PSEG Public Service
Electric and Gas
Company

HOPE CREEK GENERATING STATION
DOCKET NO. 50-354
FSAR COMMITMENT STATUS THROUGH SEPTEMBER 1984

ATTACHMENT I
HOPE CREEK GENERATING STATION
FSAR COMMITMENT STATUS THROUGH SEPTEMBER 1984

Figure 9B-1 Model for canister and portion of bottom grid

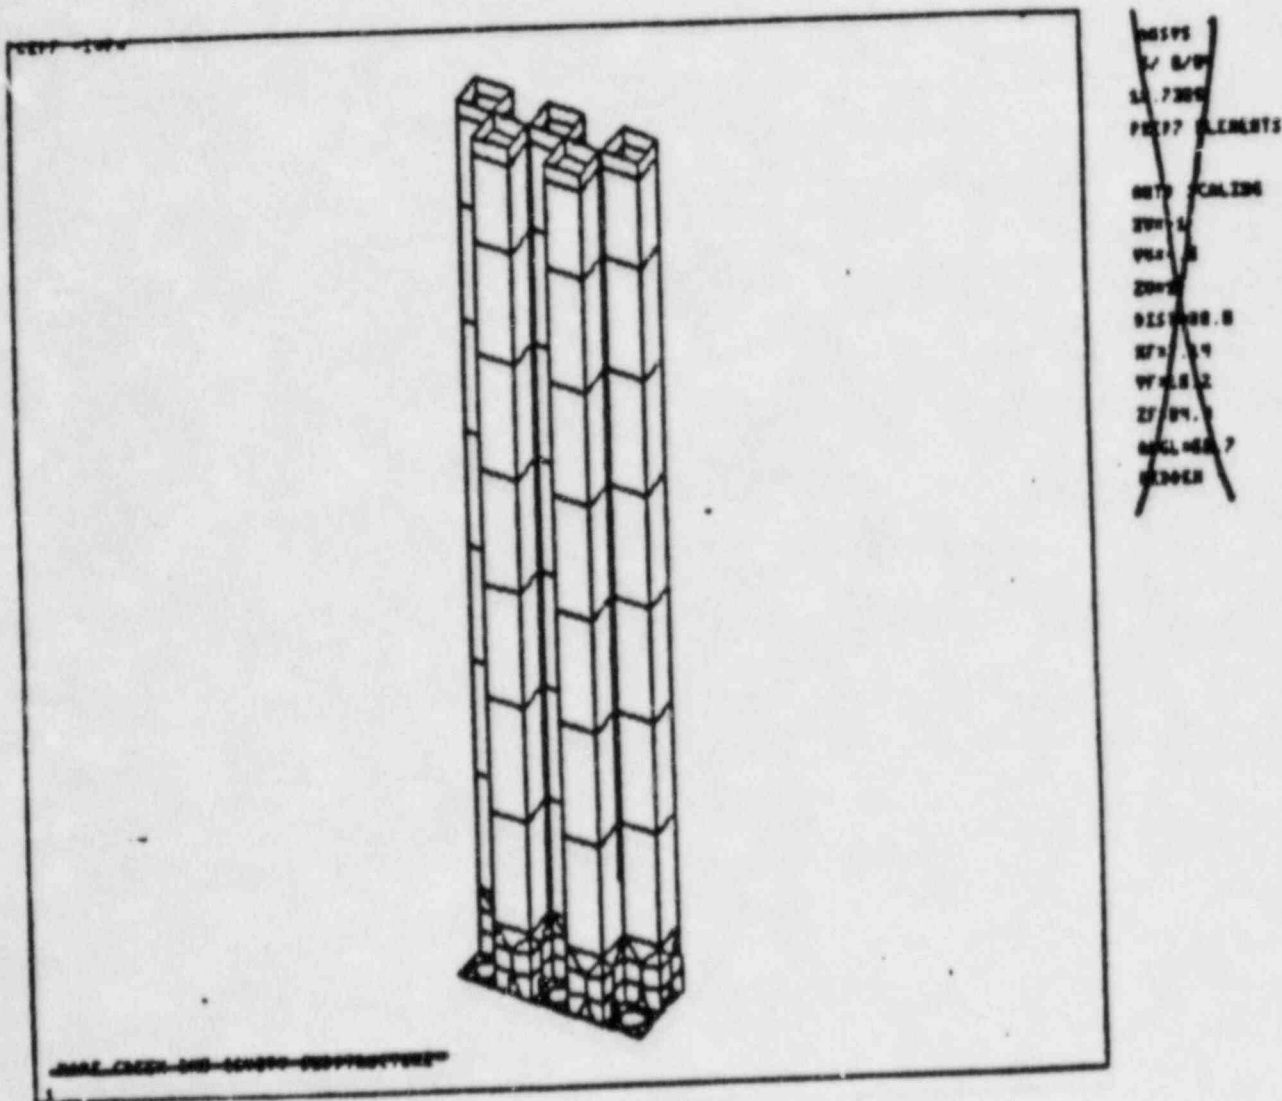
Each fuel rack is idealized as a 3D finite element model. Figure 9A-1 shows a five canister portion of a rack. The canisters and bottom grid plate are modeled with plate elements. The perimeter bar, which secures the canisters at the top, and the stiffening bars for the grid plate are modeled with beam elements. The thin stainless steel wrapper containing the neutron absorber and the stainless steel panels used to close off the alternate cavities are not modeled but their masses are included. The fuel assemblies are modeled as beam elements.

(typist - change "3D" to "three dimensional" in all places)

Figure 9B-2. Double rack model for detail seismic analyses on fuel/rack and rack/rack interaction

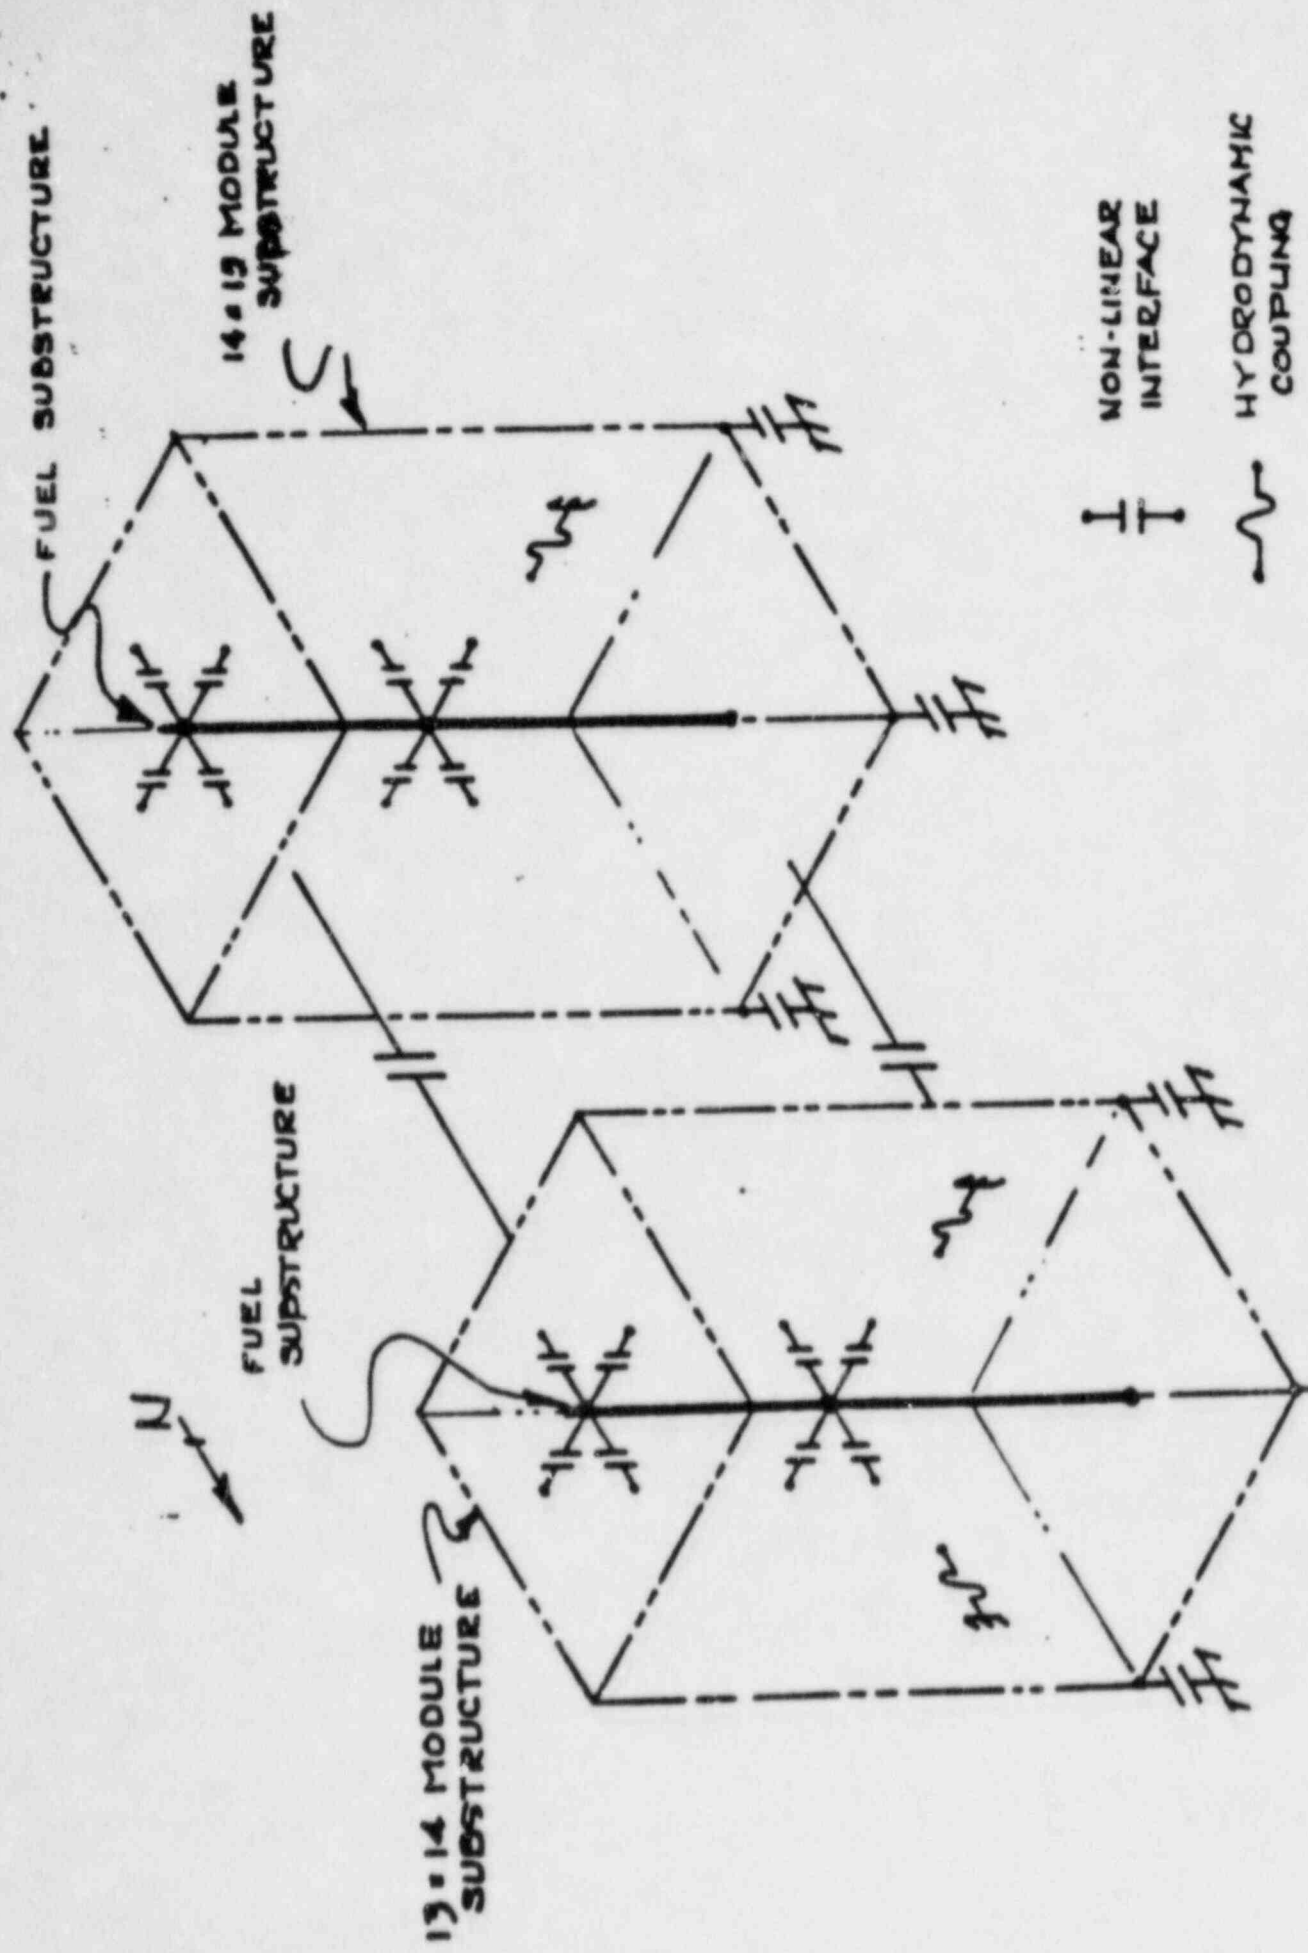
Figure 9A-2 shows a double rack model in schematic form. 3D interface elements are used to represent the fuel-to-canister clearance as well as the rack-to-rack gap. These nonlinear elements reproduce forces due to fuel rattling and possible rack-to-rack interaction. 3D gap elements with material properties based on the interface friction coefficients are used to simulate the corner supporting feet which may slide or lift off the pool floor. Two

bounding values of friction coefficient (0.2 and 0.8) are used in order to identify the most critical conditions for sliding and for maximum reactions at the support feet.

Structural damping coefficients of 2 per cent for OBE and 4 per cent for SSE are used, except that impact damping of 10 per cent of critical is used for the gap elements since impact dissipates substantial amounts of energy. With 20 feet of submergence, sloshing effects are negligible and therefore are neglected. Fluid damping effects are also neglected. To simulate the immersion effects, all the internal water entrapped within the rack envelope is added to the horizontal mass. The external water between adjacent racks is modeled using the hydrodynamic coupling element shown in Figure 9A-2.
